TO: Troy Kelts, Galloway & Company
FROM: Stacey Nerger, Senior Planner
DATE: February 22, 2024
SUBJECT: The Exchange Lot 1 – Site Plan
Review Comments 03

EXCHANGE LOT 1 SITE DEVELOPMENT PLAN

Description: **The Exchange L1 - Site Plan Amendment Addition and Remodel**

COVER SHEET

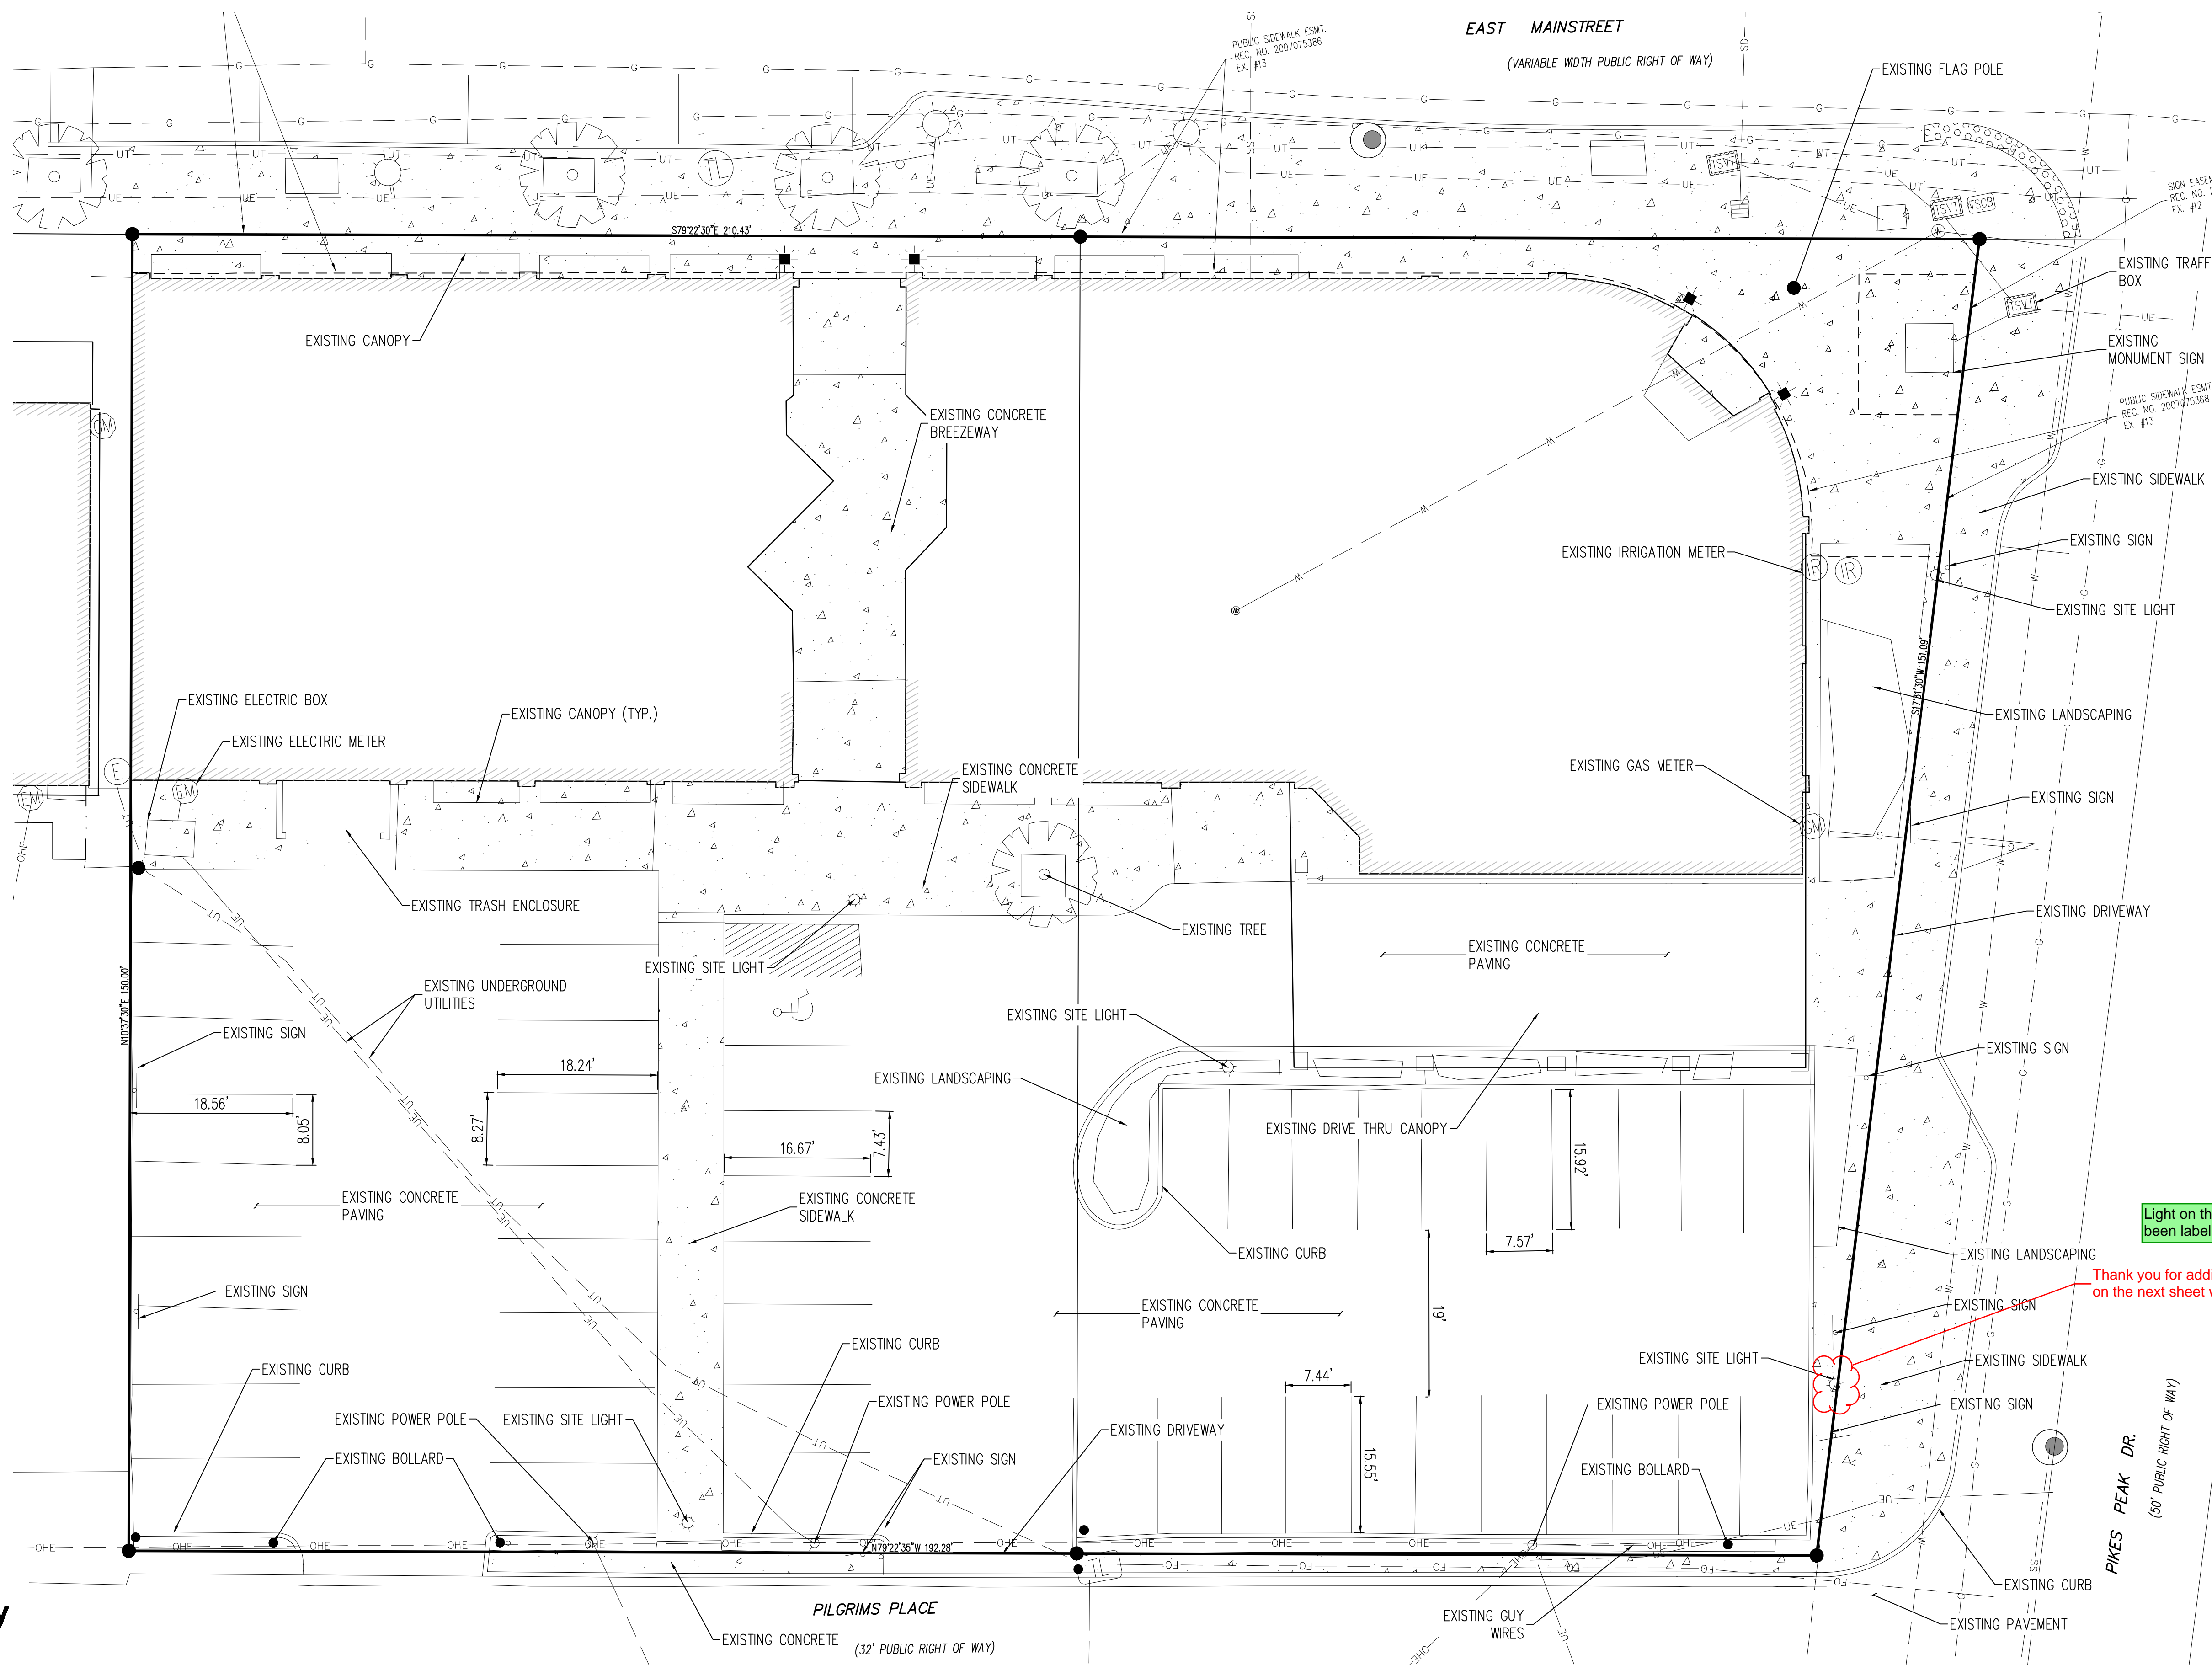
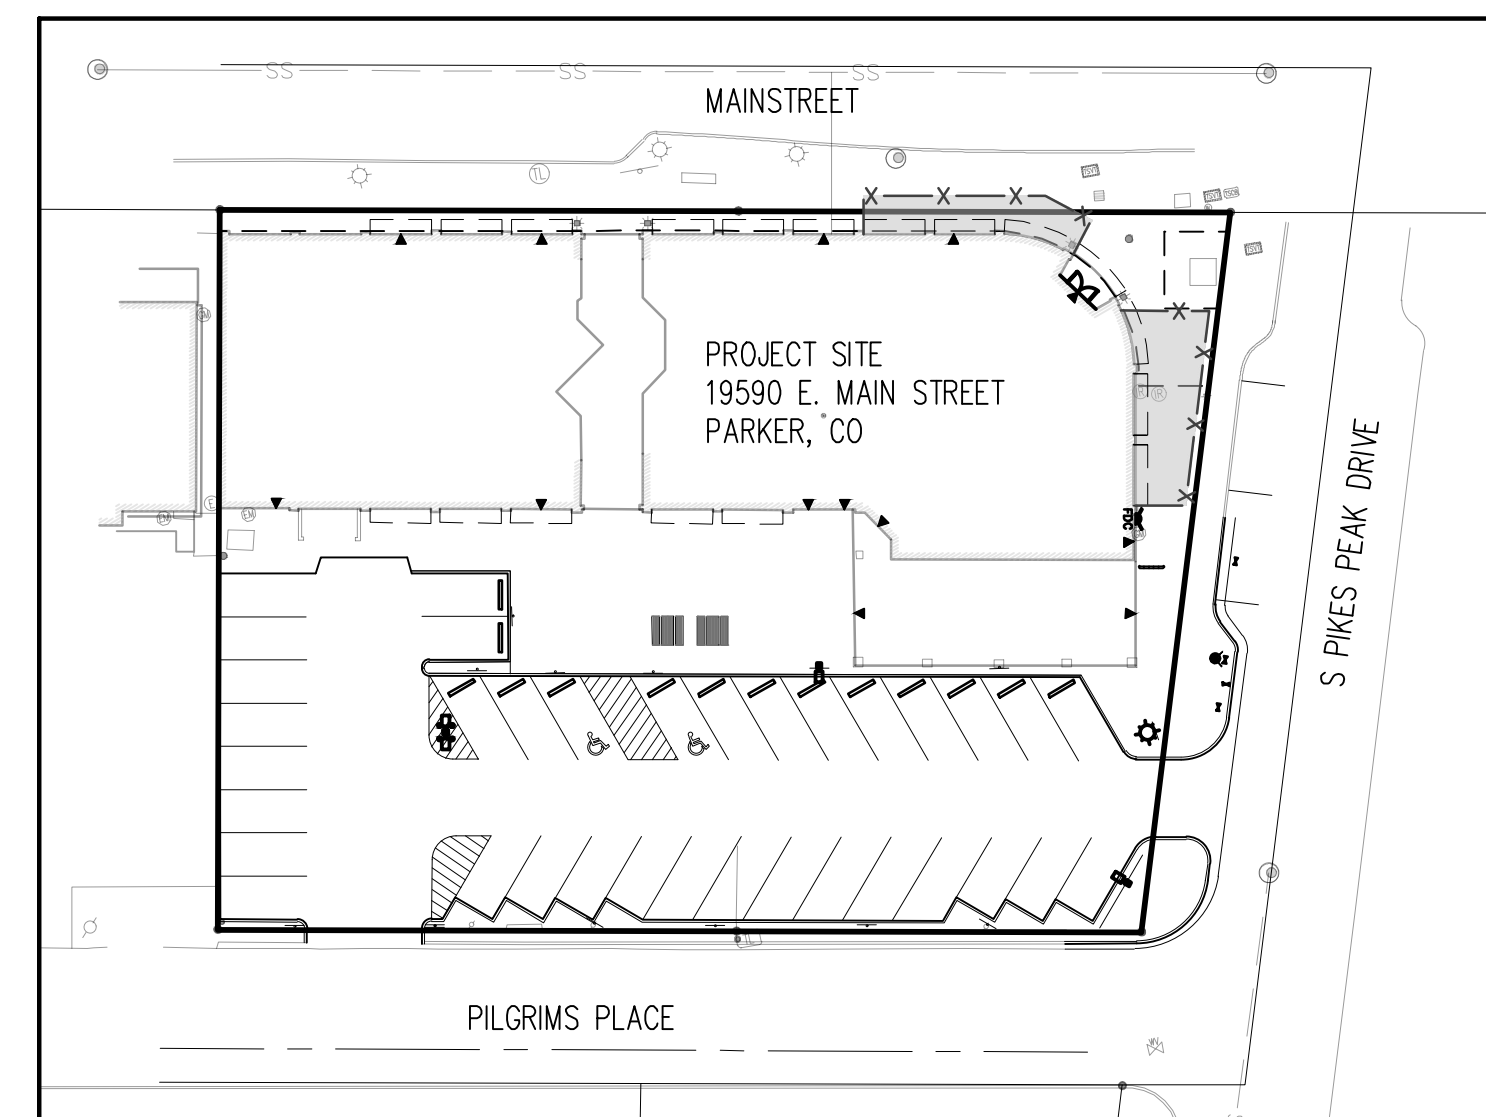
This is labeled hardscape. Does this number reflect parking and access aisles only, or does it include hard surface landscaping as well? If the former, this number is correct to use in your trees and shrubs per 1500 ft calculations. However, if it also includes hard surface landscaping, your calculations are incorrect.

This calculation does not match up with the same measurement on sheet 4, which is 3340. Staff believes this number is correct and sheet 4 is incorrect. Either way, they must match.

Numbers have been updated to reflect the plaza included in the landscape, and drive aisles and parking, etc. included in a separate table row

The table on sheet 4 has been updated to match the site statistics table data

EXISTING
CONDITIONS PLAN
2
2 OF 19

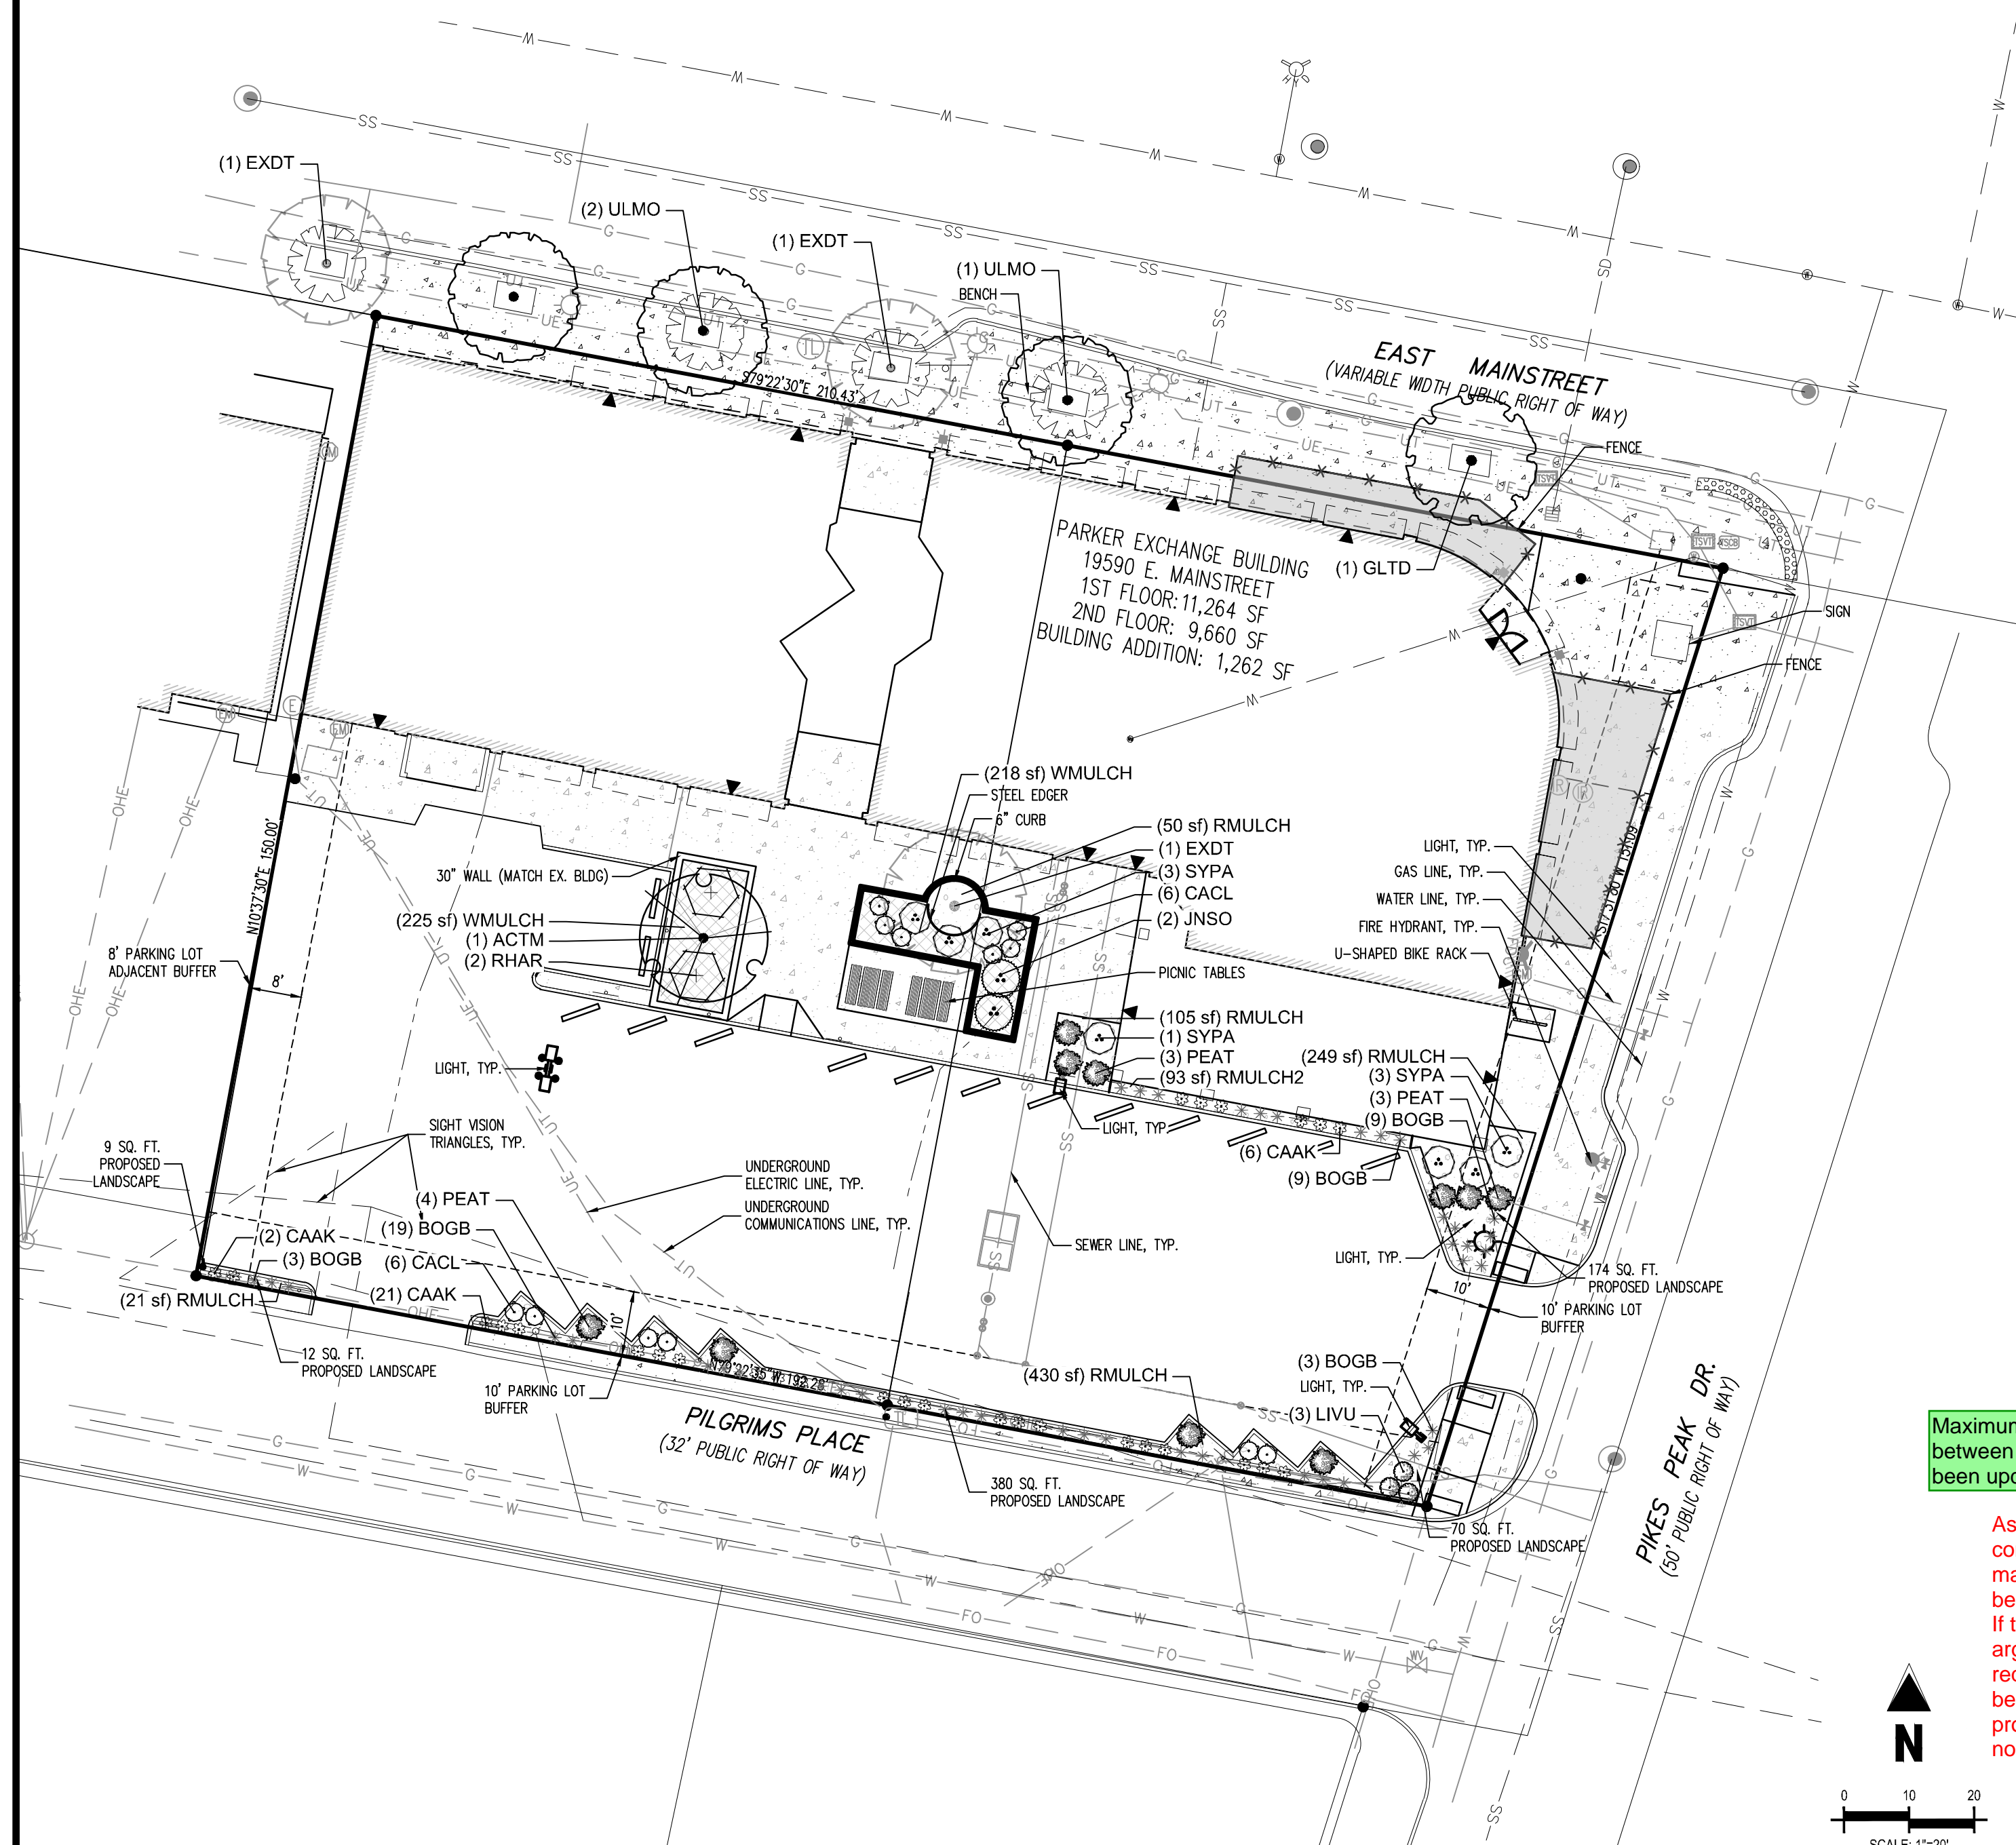
Thank you for adding this to this sheet. Please also label on the next sheet where this will be relocated to.

Light on the next sheet has been labeled as requested

DuMor, inc. TABLE 443 SERIES-2

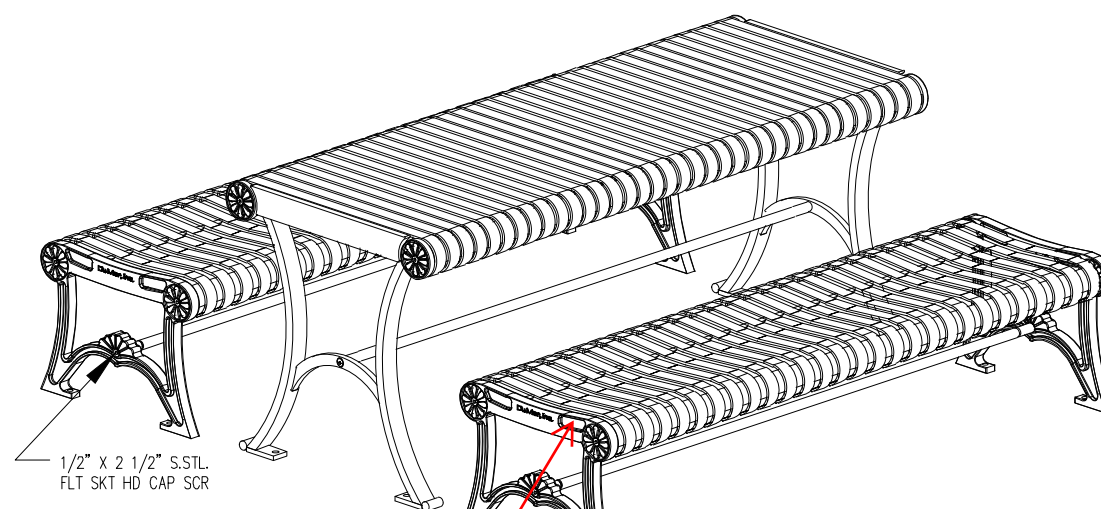
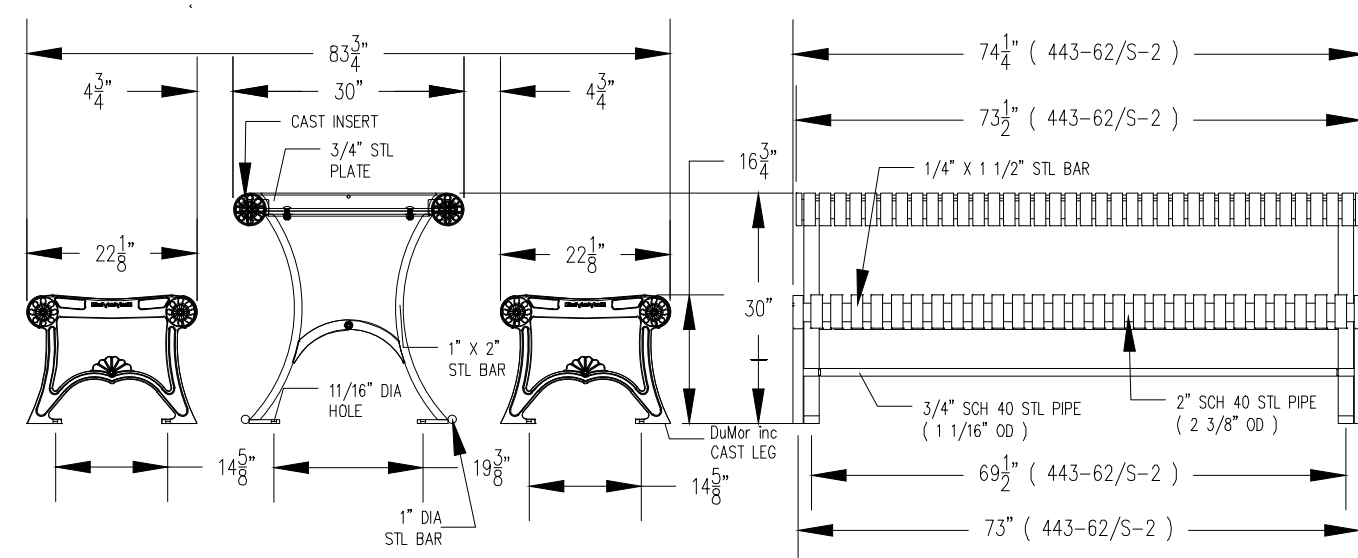
Please add color

Color specification has been added to note 3
